ADDENDUM NO. 3

**RE: Item #1, July 29, 2026 Letting - EM-P 0044(207)290, PCN 05X0, Charles Mix, Gregory
County - Structure (5770'-6" Steel Girder) & Approach Grading**

DRILLED SHAFT DETAILS (A)

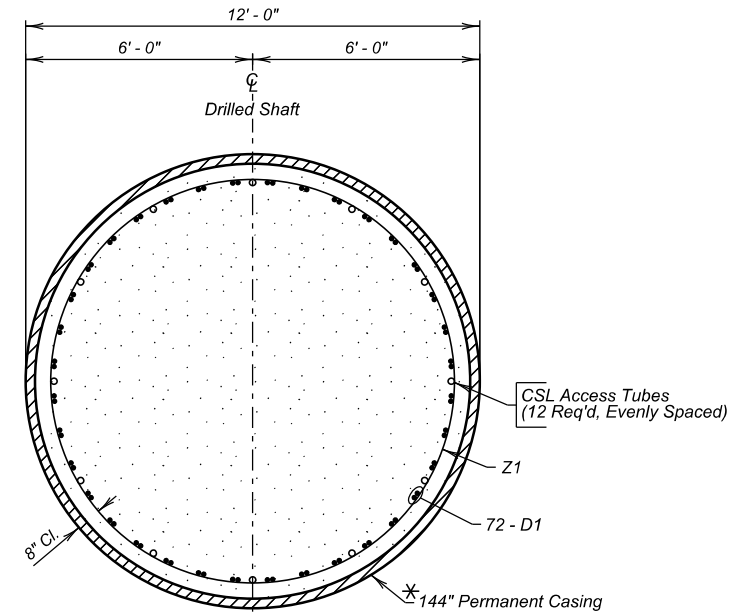
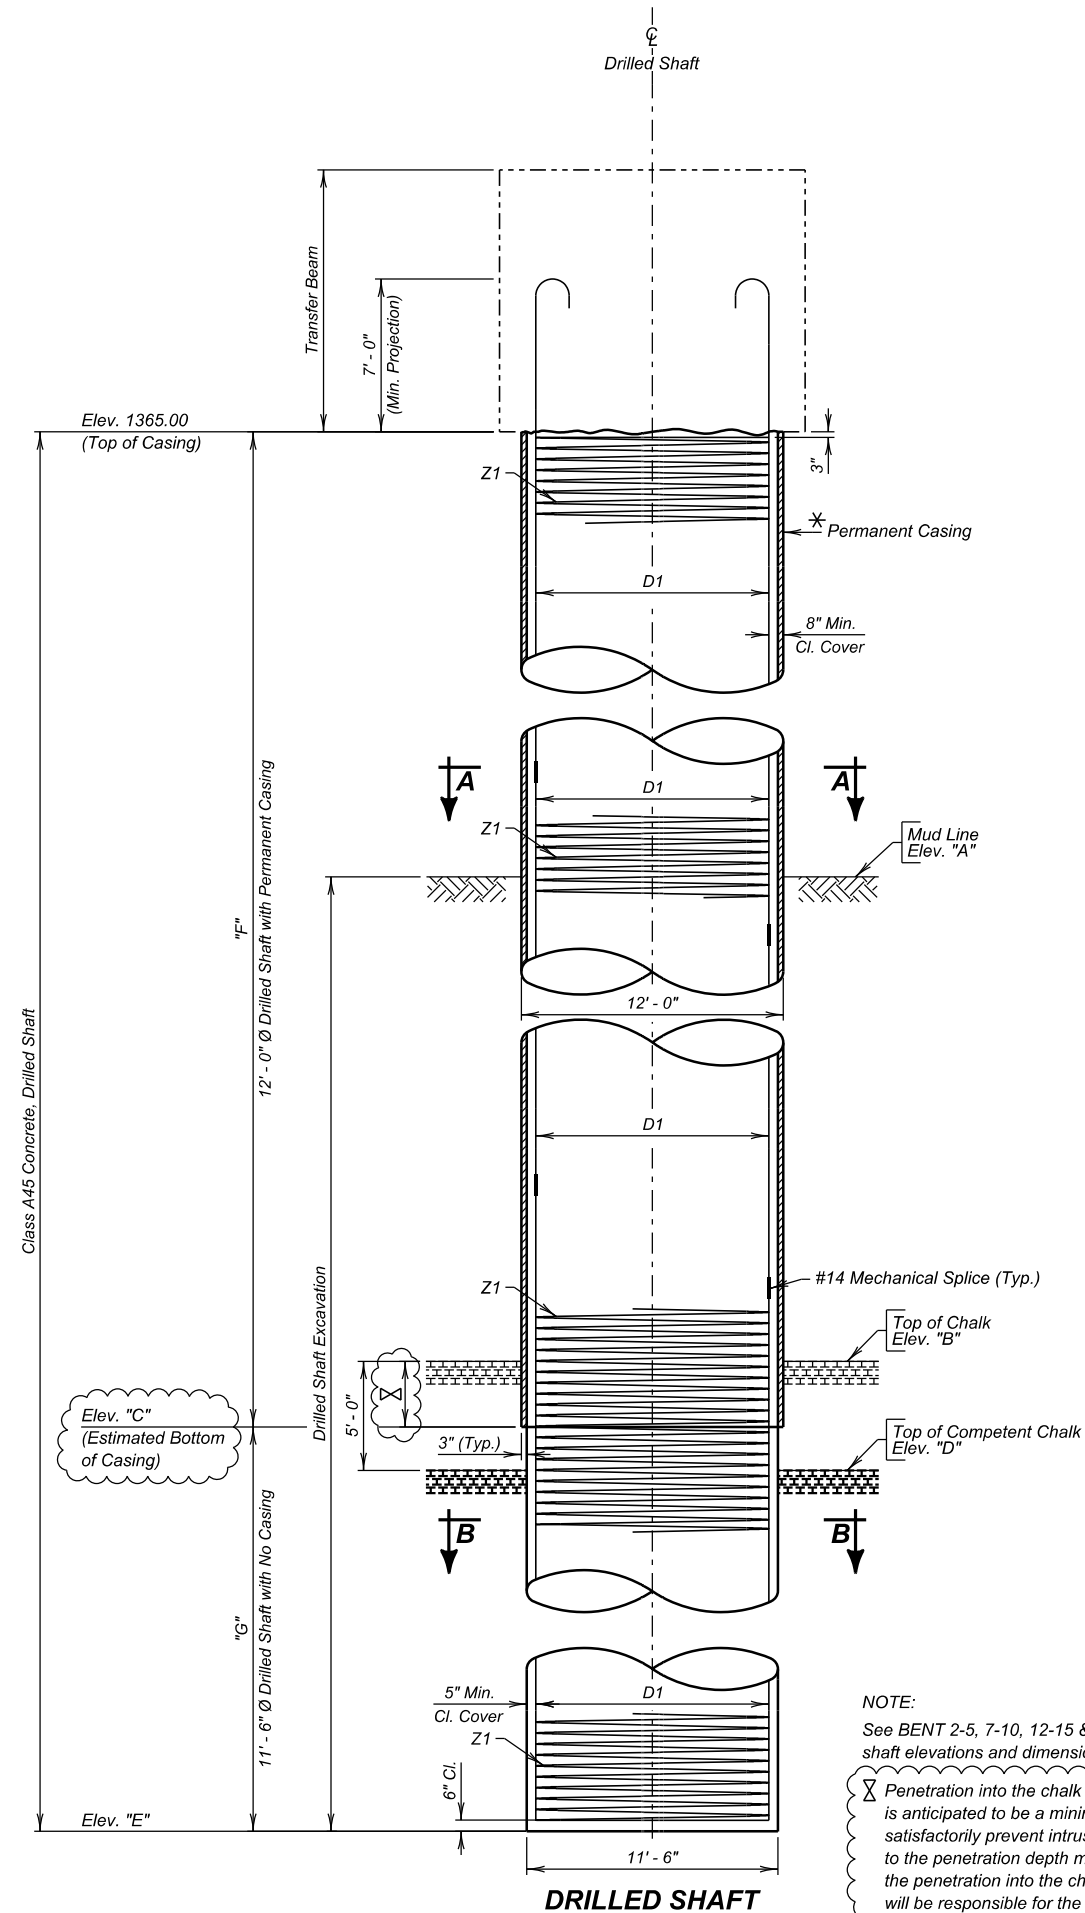
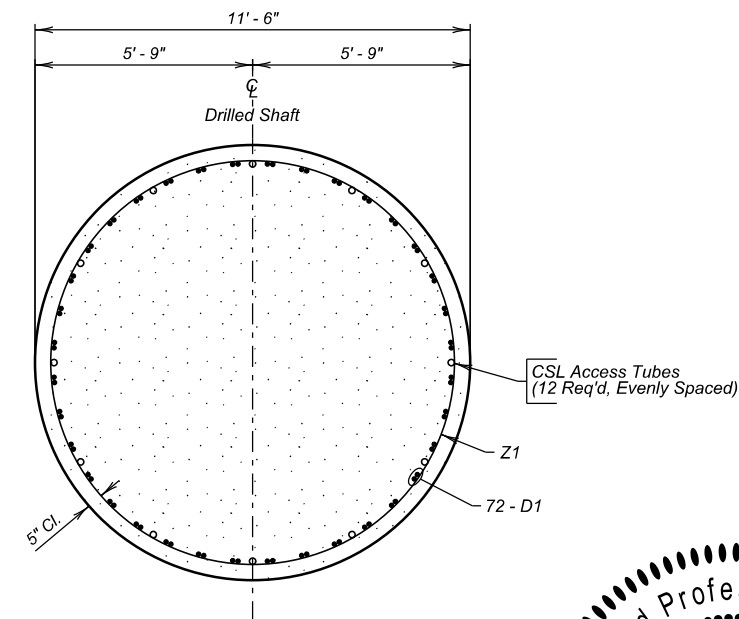
Sheet E26: Casing embedment length and Elev. "C" were revised on DRILLED SHAFT view.

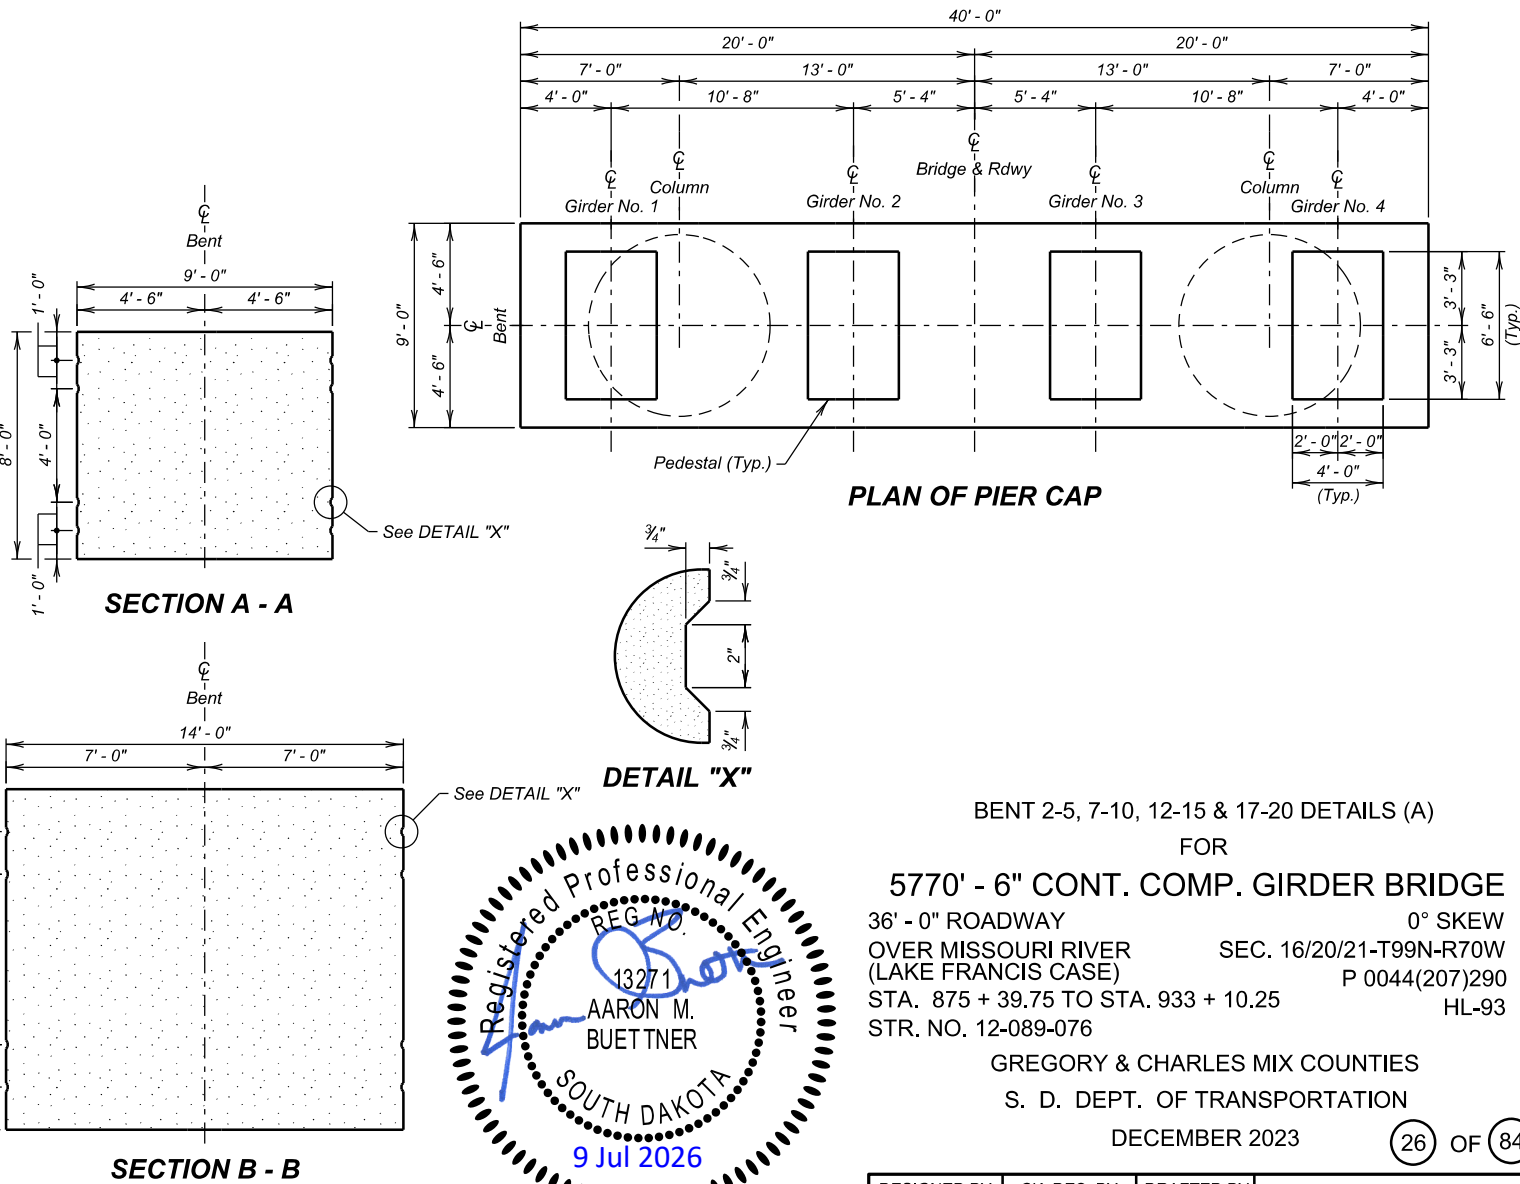
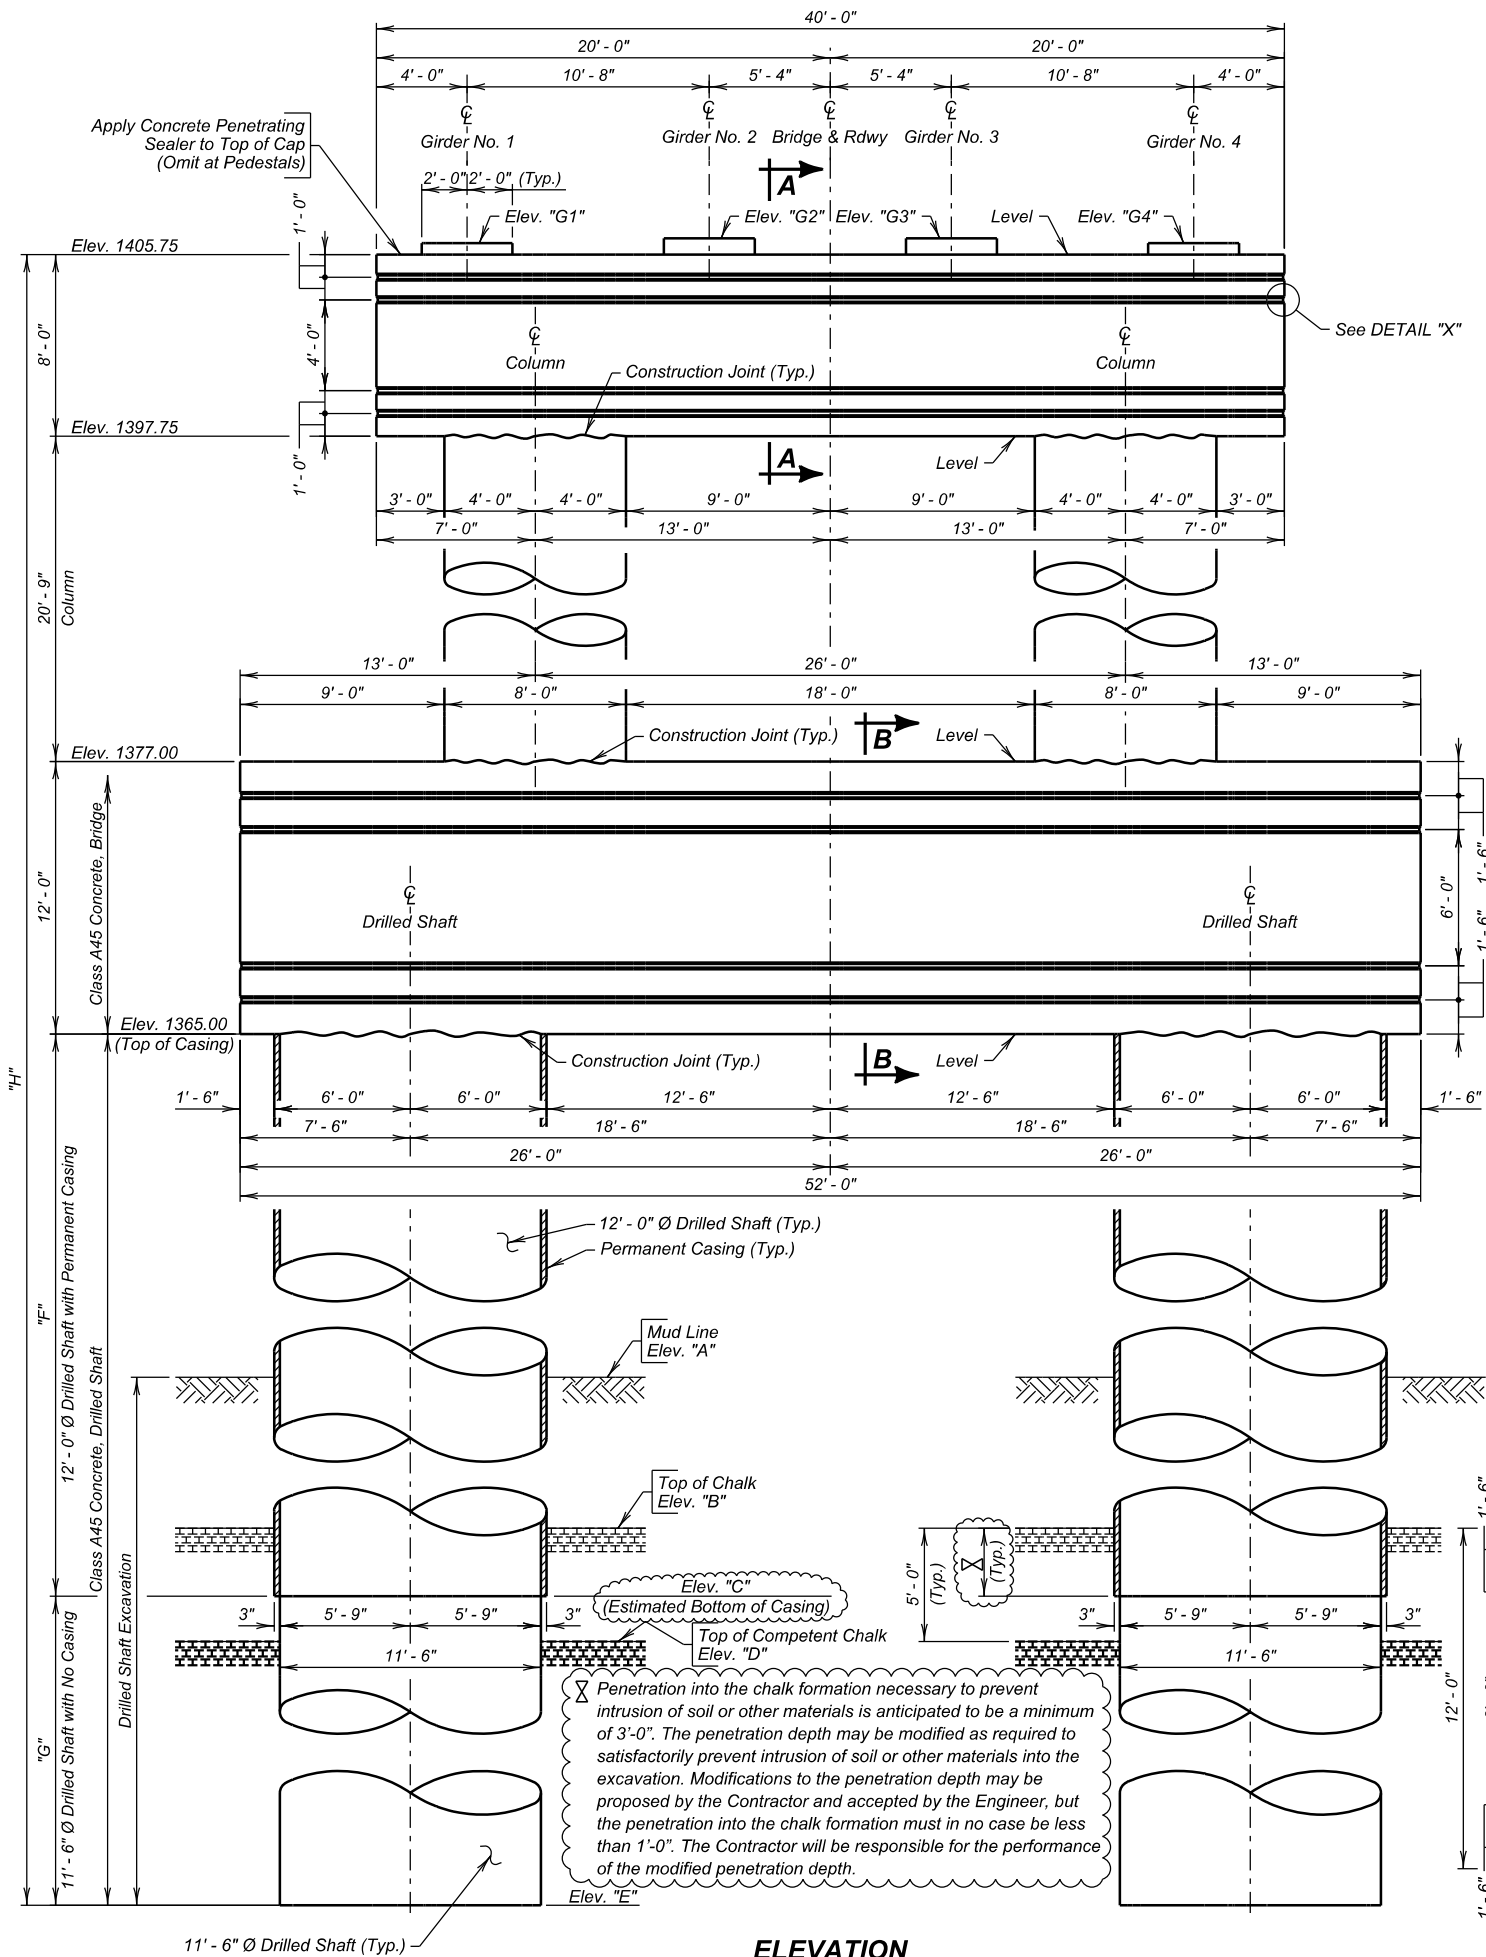
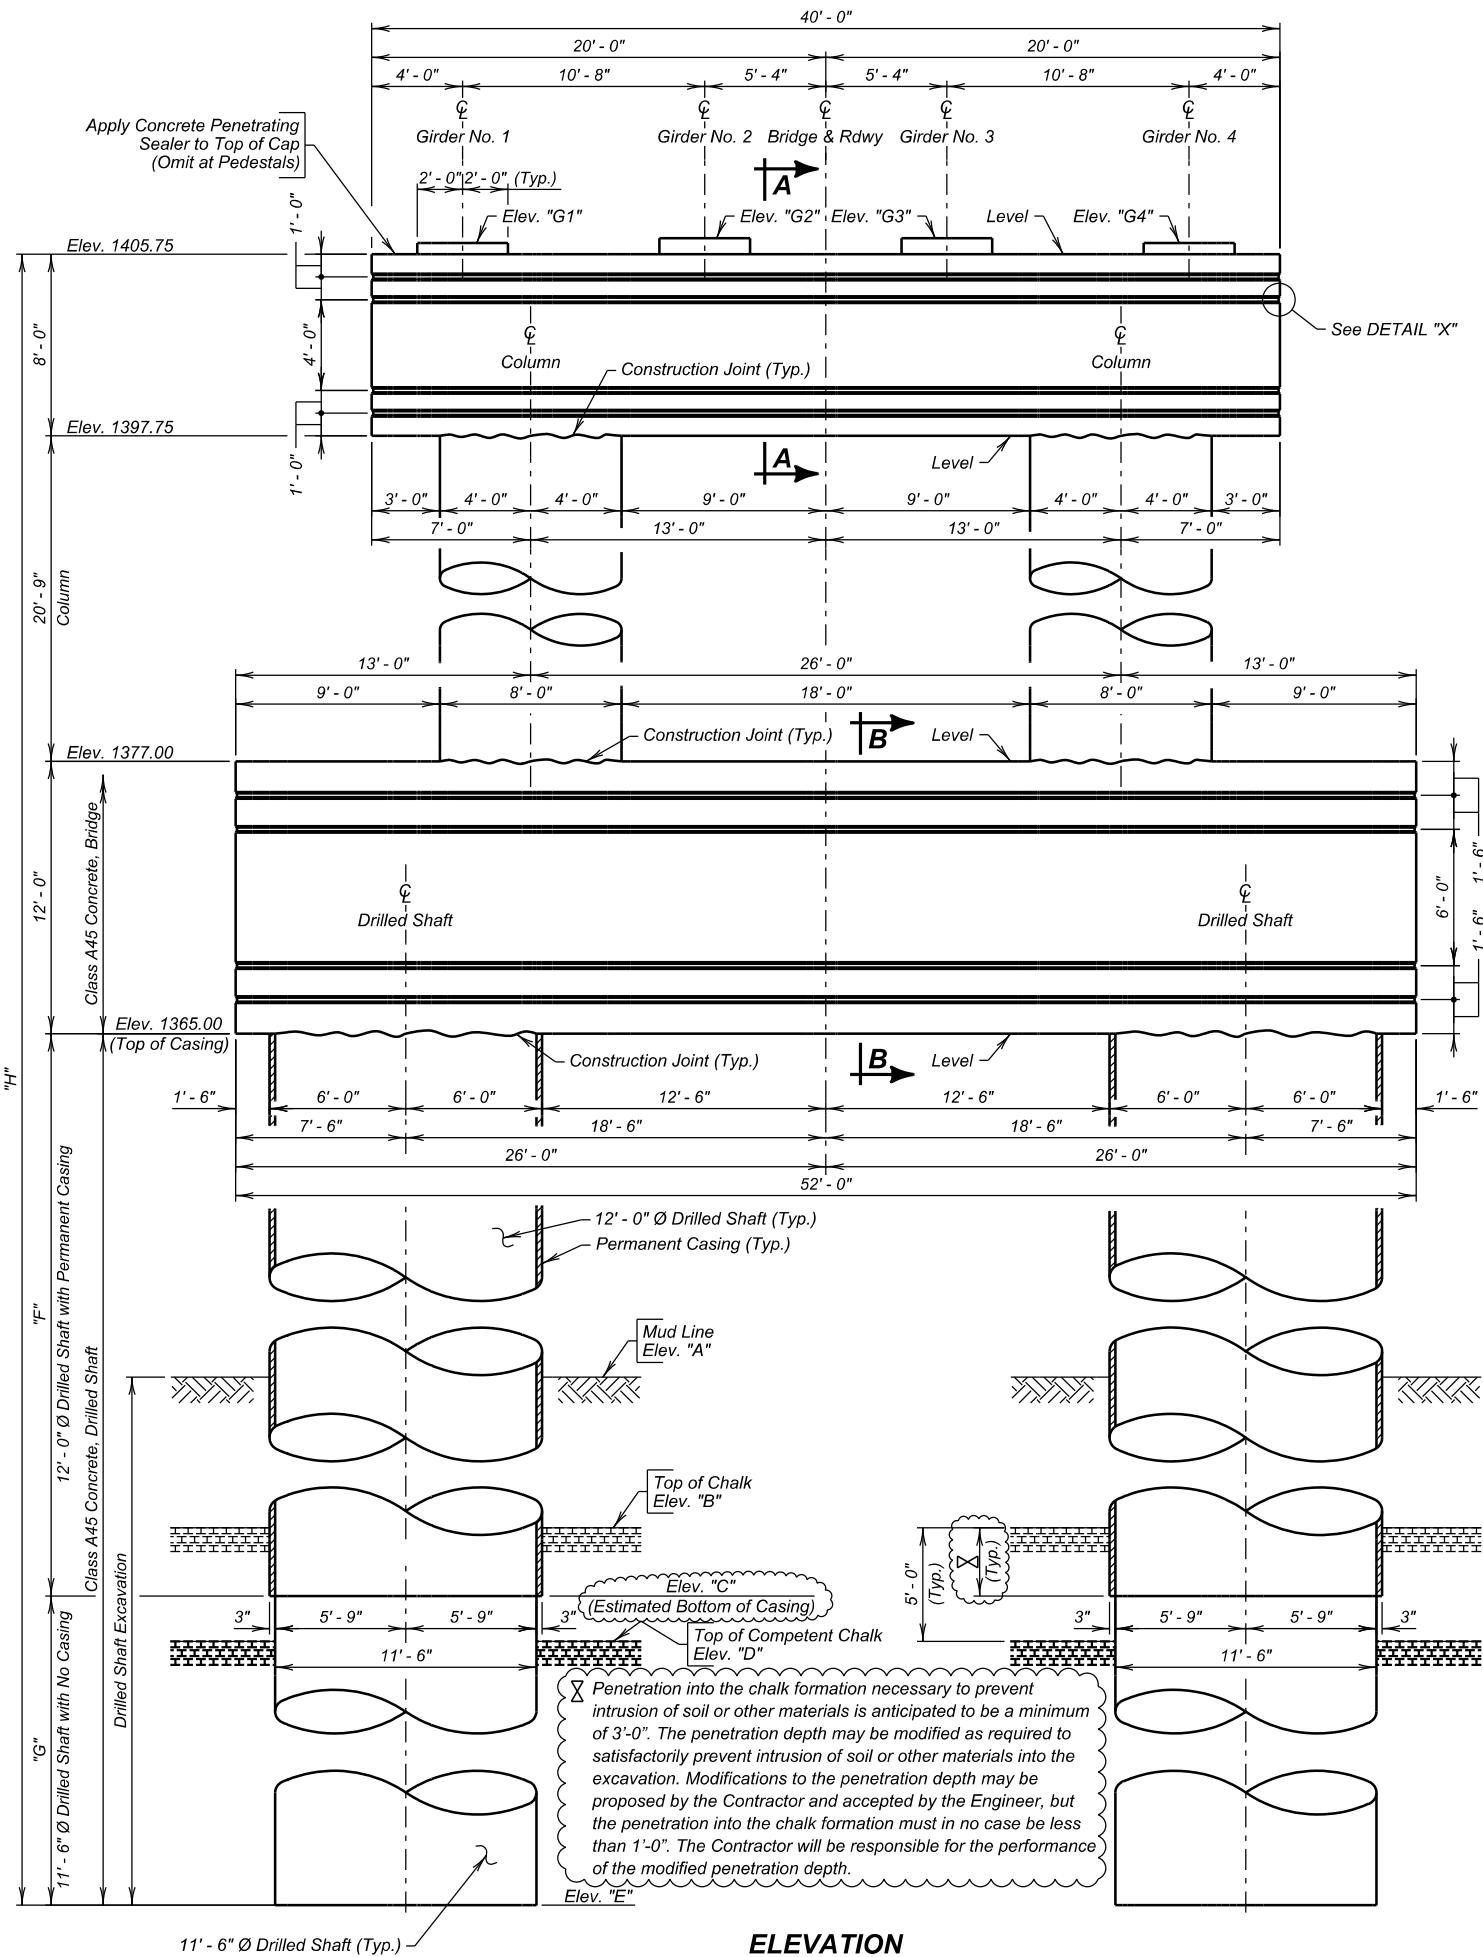
Sheets E28 & E31: Elev. "C" was revised on ELEVATION view.
